**RE: Mesa Del Sol Self Storage
5500 Turing Dr. SE
Grading and Drainage Plan
Engineer's Stamp Date: 5/7/2025
Hydrology File: R16DA1004**

**Re: Mesa Del Sol Self Storage
 5500 Turing Dr. SE
 Grading and Drainage Plan
 Engineer's Stamp Date: 01/15/2025
 Hydrology File: R16DA1004**

Here are the responses to the comments provided on March 21, 2025 in regards to an **Updated Grading & Drainage prior to continuing onsite grading and foundation work.**

CIVIL DETAILS.

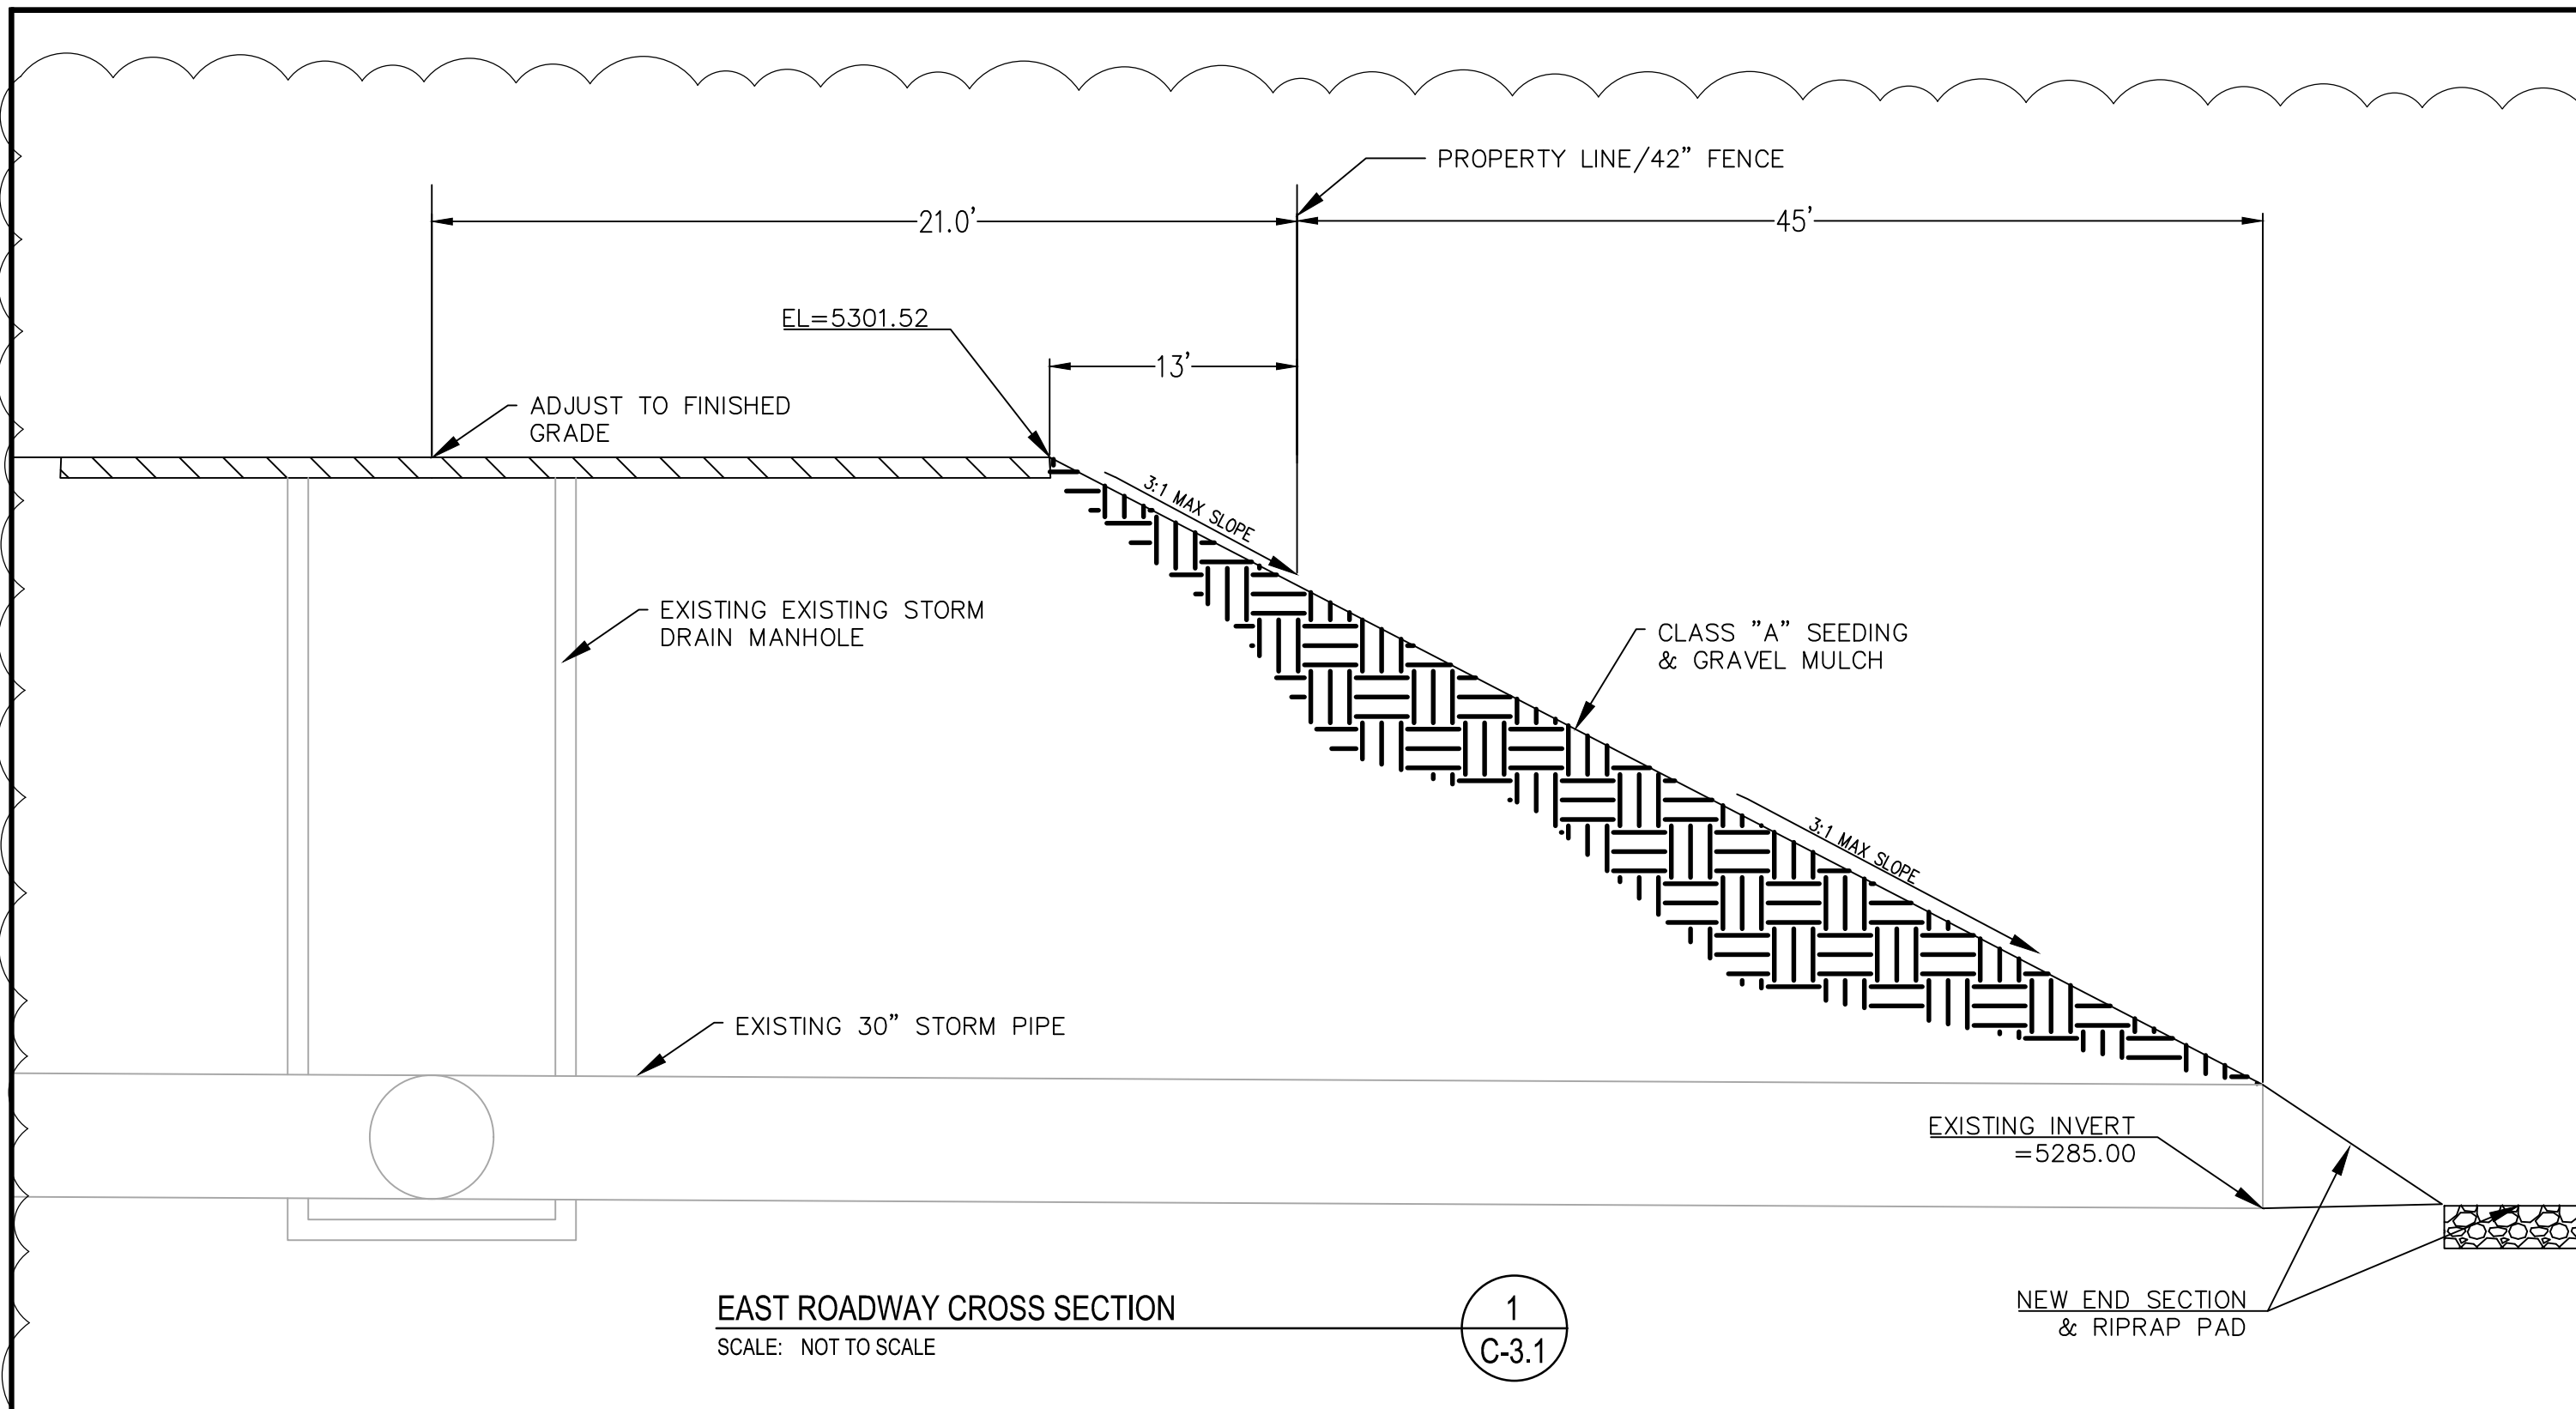
8. Due to the proposed retaining wall in Section 1 of C-3.1, provide an additional cross-section showing the existing storm drain manhole and pipe extension through the proposed retaining wall and into the retention basin at the southeast corner of the project.
Concur. Additional section has been added, see revised sheet C-3.1 & C-3.2. Retaining wall removed from revised design.
